ATTACHMENT 4

UNIT 1 – AREA WALK-BY CHECKLISTS

NO. SNCV061-RPT-01

A total of 75 Area Walk-bys have been completed.
The Checklists are provided within this Attachment.

Location: Bldg. NSCW Floor El. 220' Room, Area¹³ R 203
PLUMB WORK

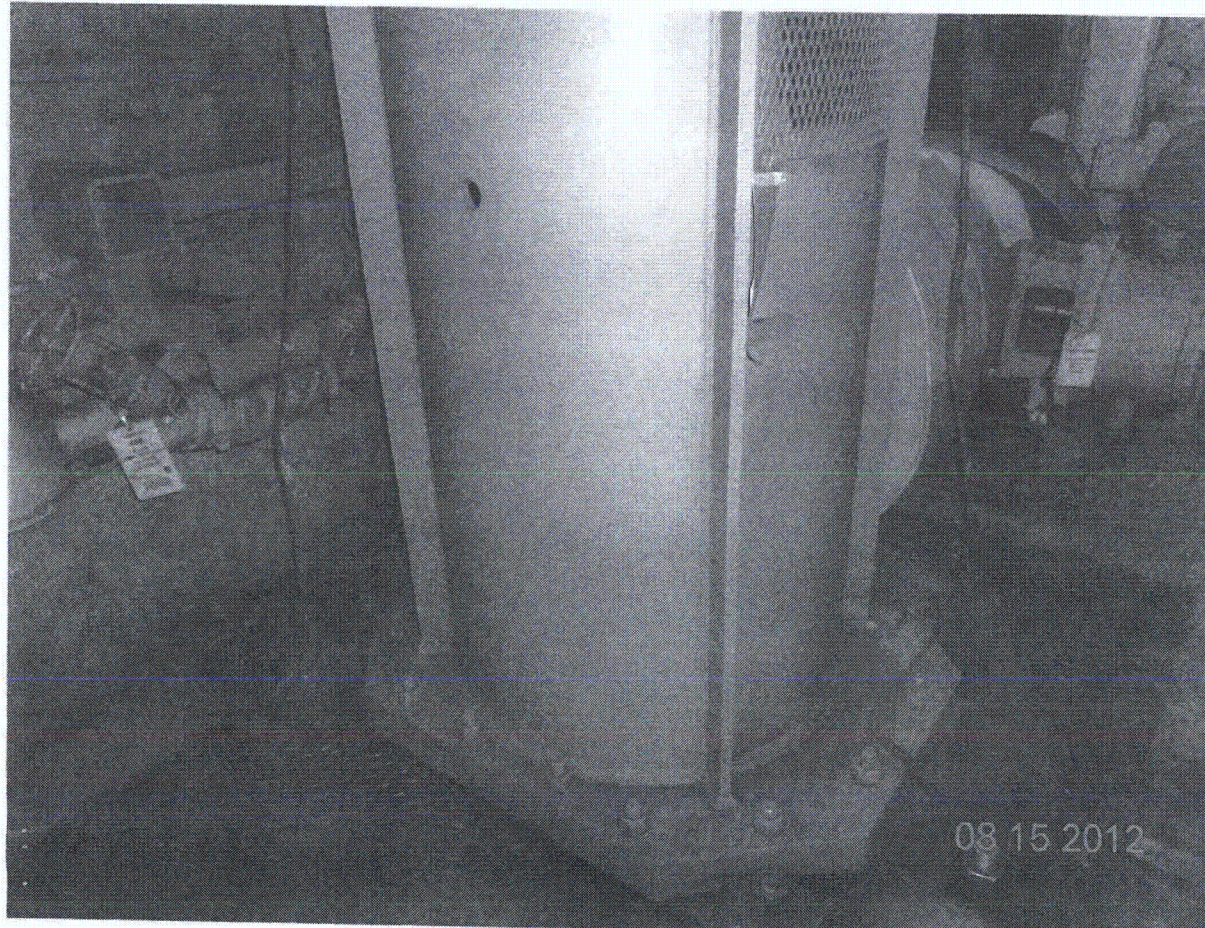
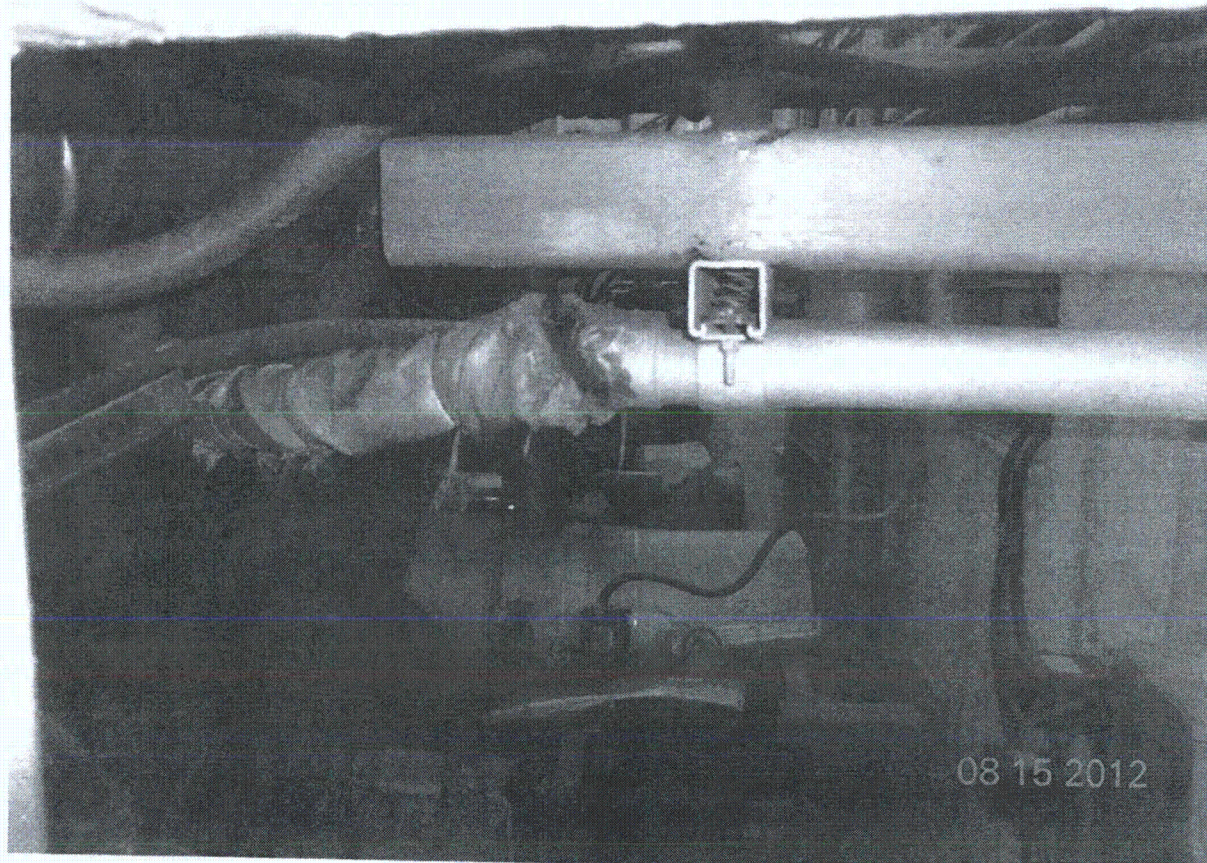
*OVERHEAD VALVE SHOWS MINOR/MODERATE CORROSION
NOT A SEISMIC CONCERN*

Location: Bldg. AUX Floor El. 245 Room, Area¹³ R 202

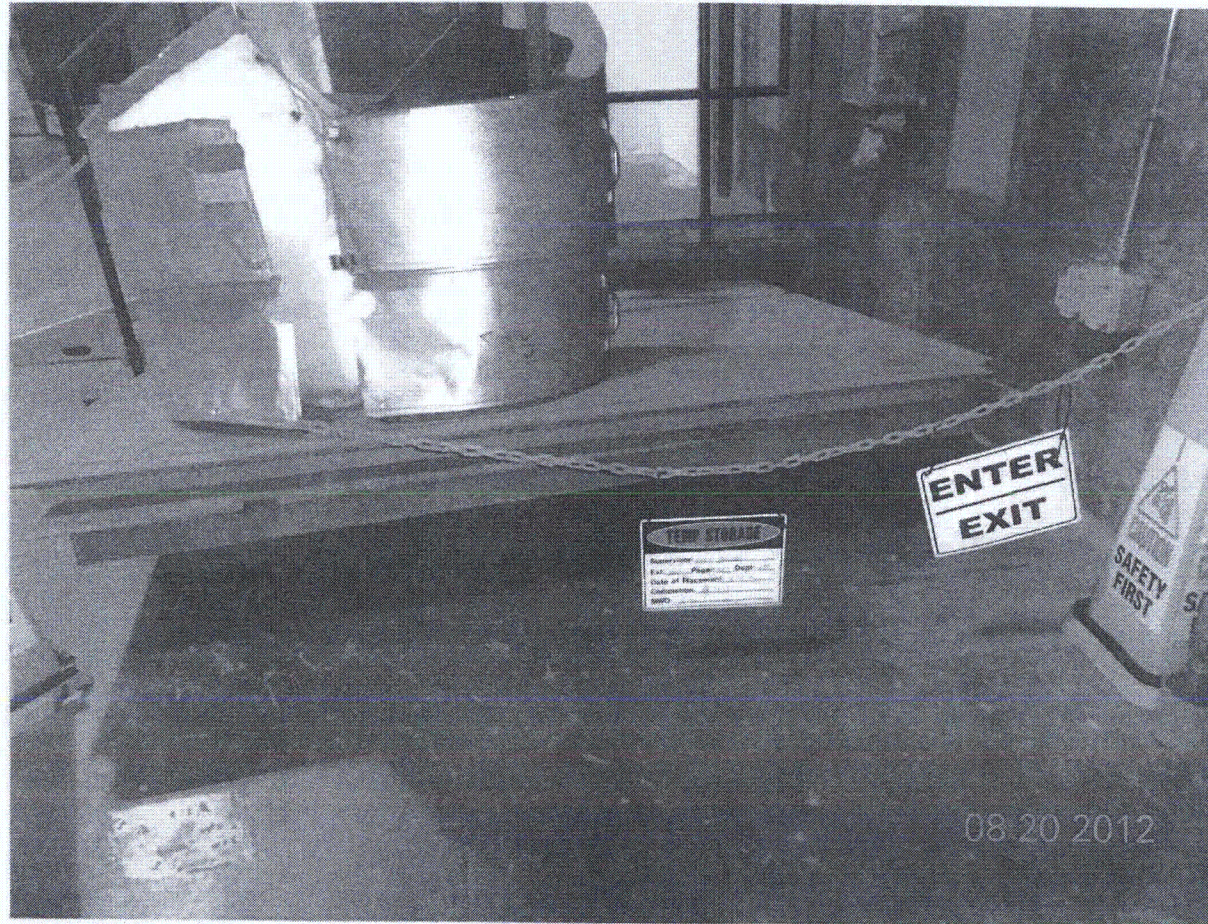
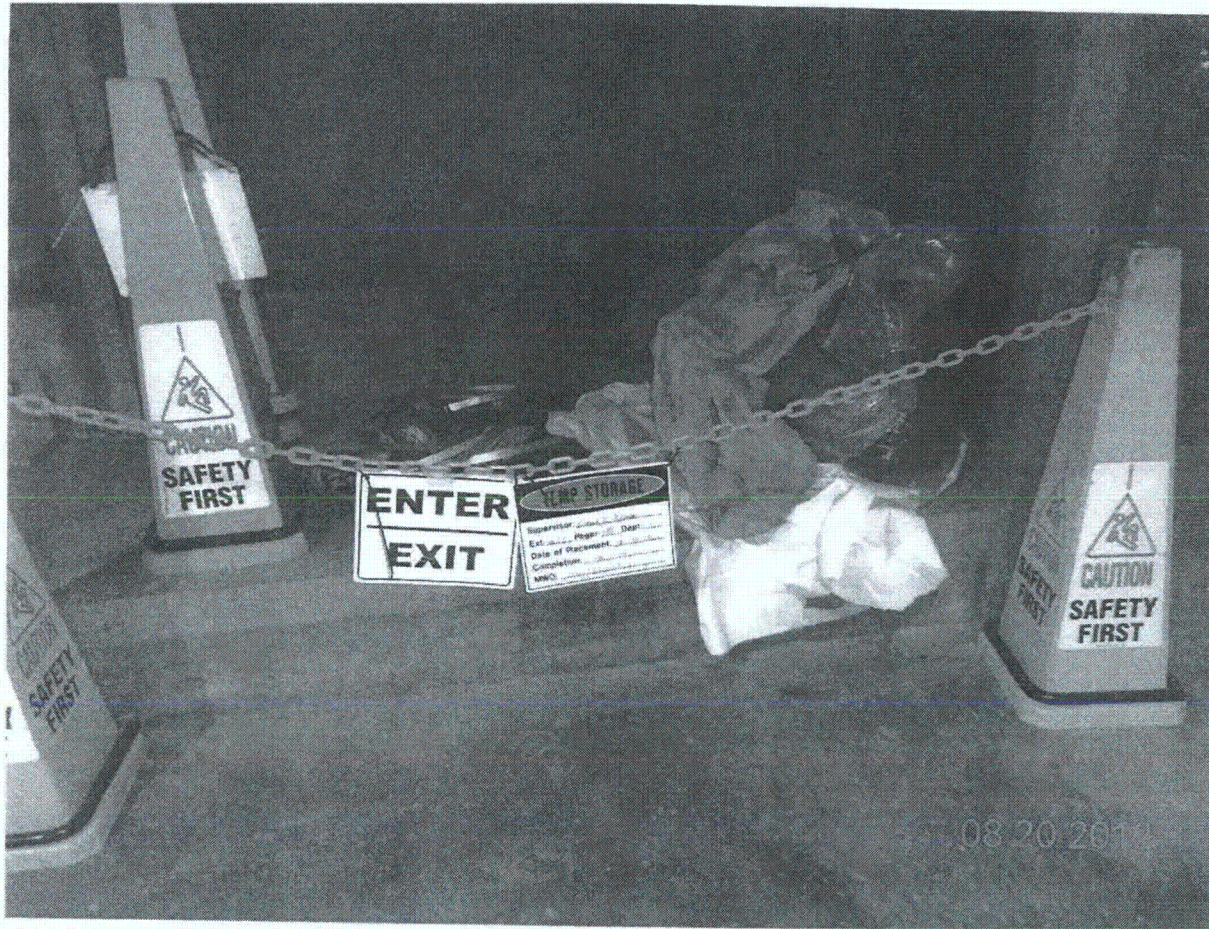
Temporary storages with NO and scaffolding. NO in place. therefore all are acceptable

Location: Bldg. AUX Floor El. 143rd Room, Area¹³ RC91

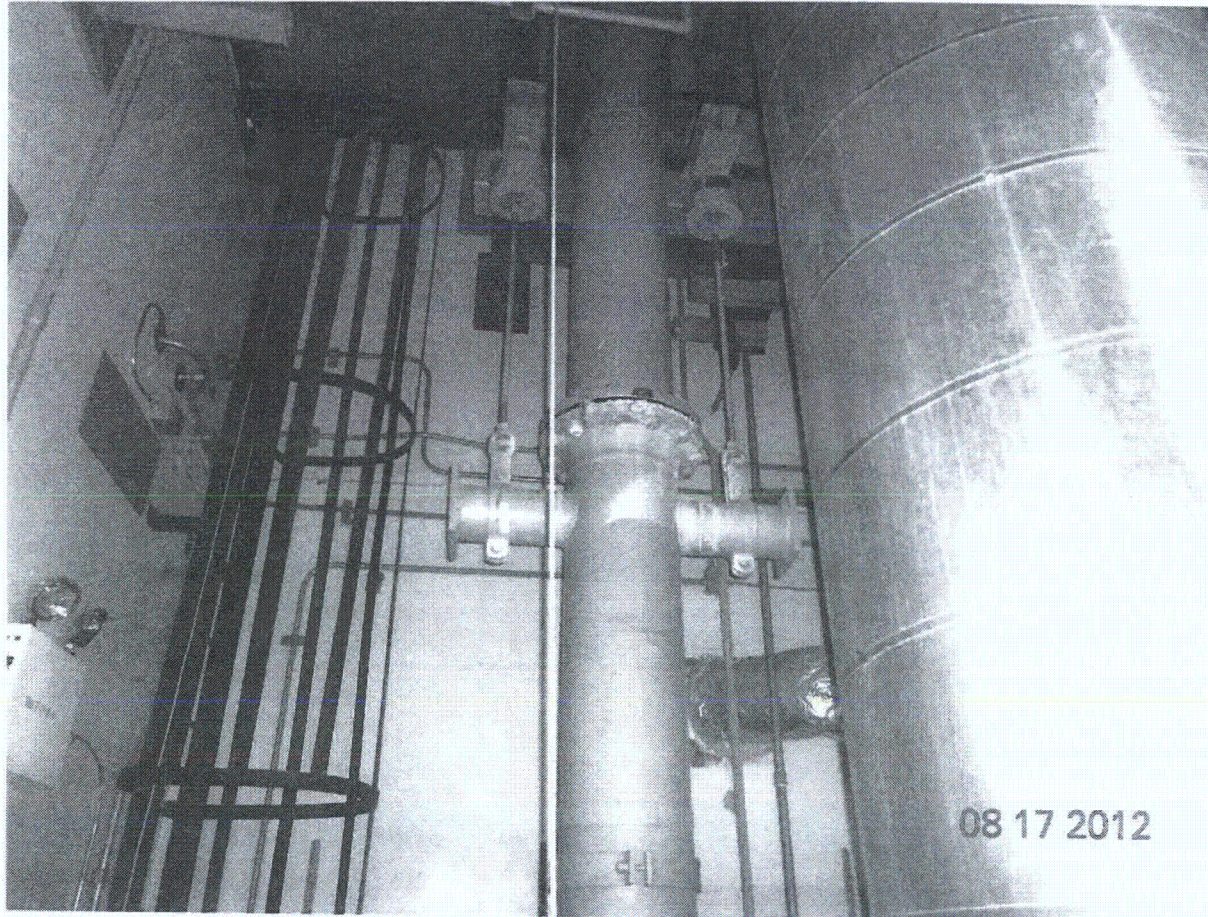
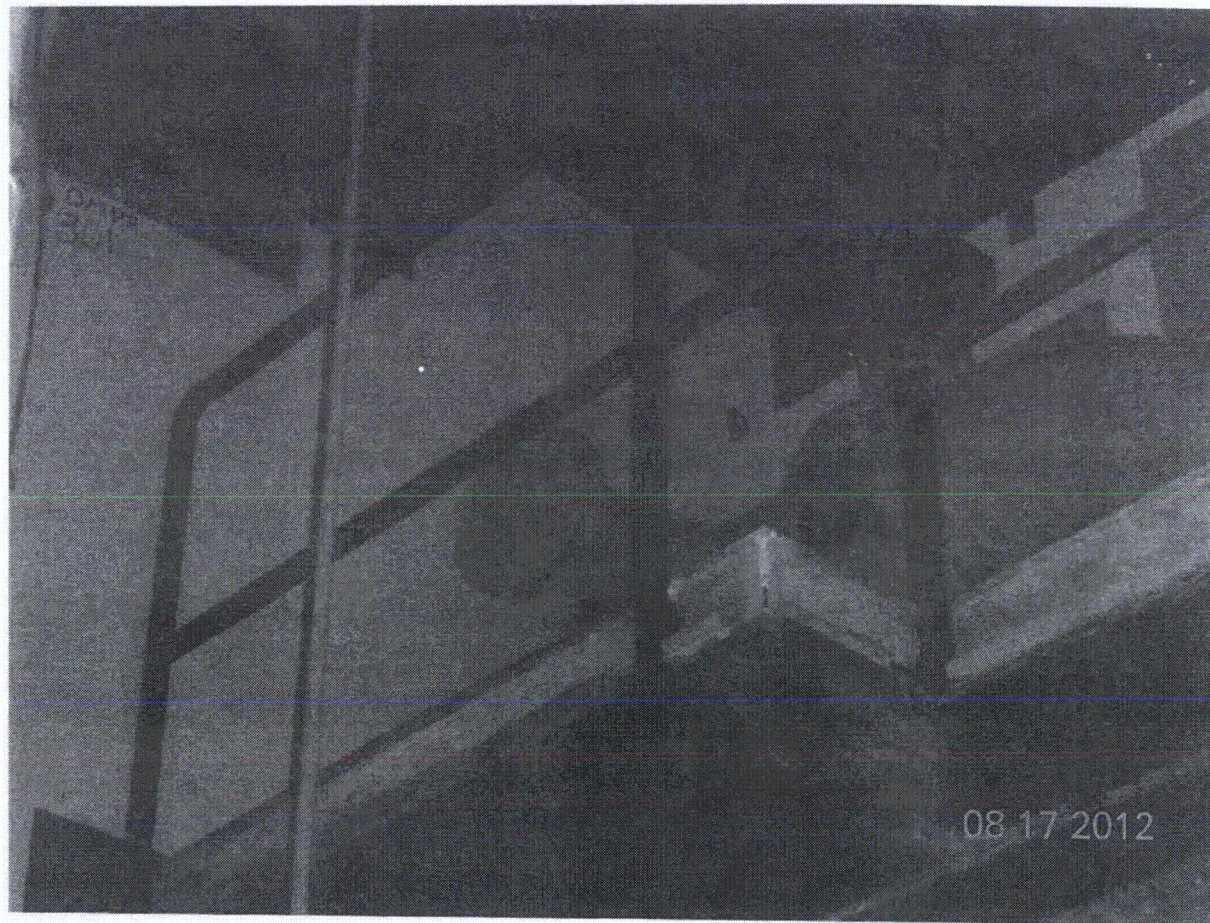
Large wrench on floor not a seismic concern - housekeeping only.

Location: Bldg. AXX Floor/El. 119.5th Room, Area is R049

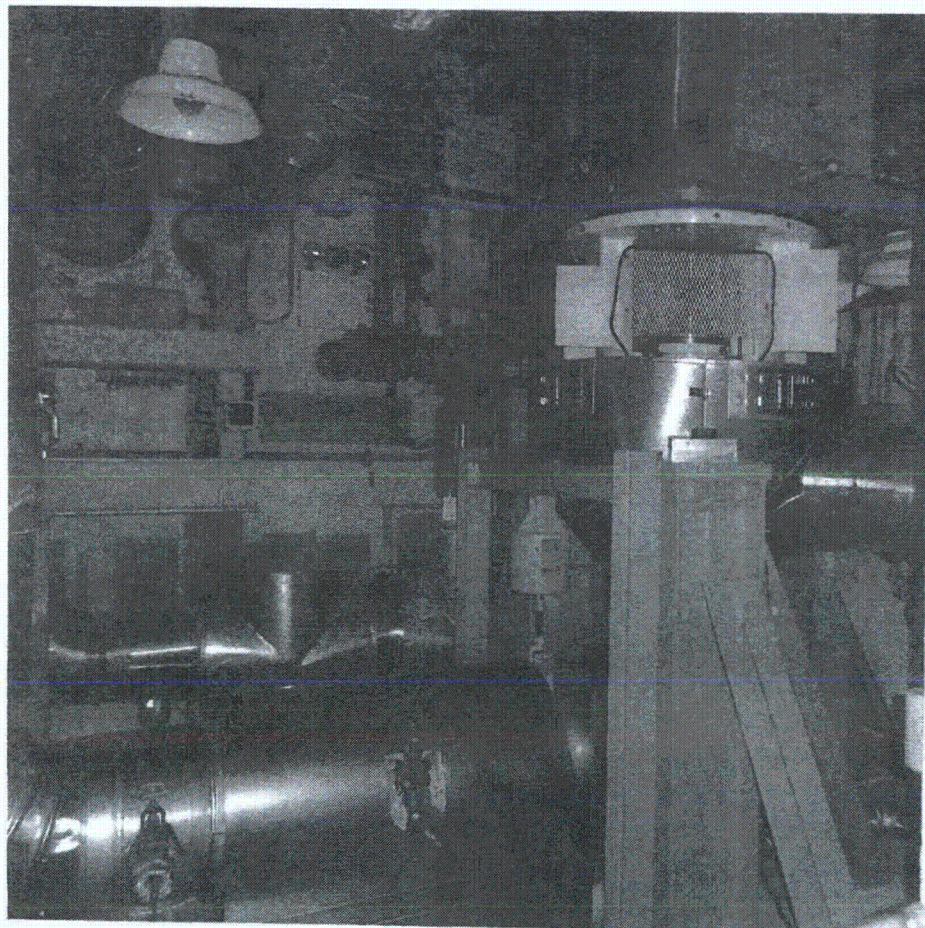
None.
Possible boric acid residue on floor not a current seismic/structural concern.
Discussed with Boric Acid Program. Issue - NO ISSUE James Dowl
James Dowl
3/11/12 DOJEL
10-26-2012
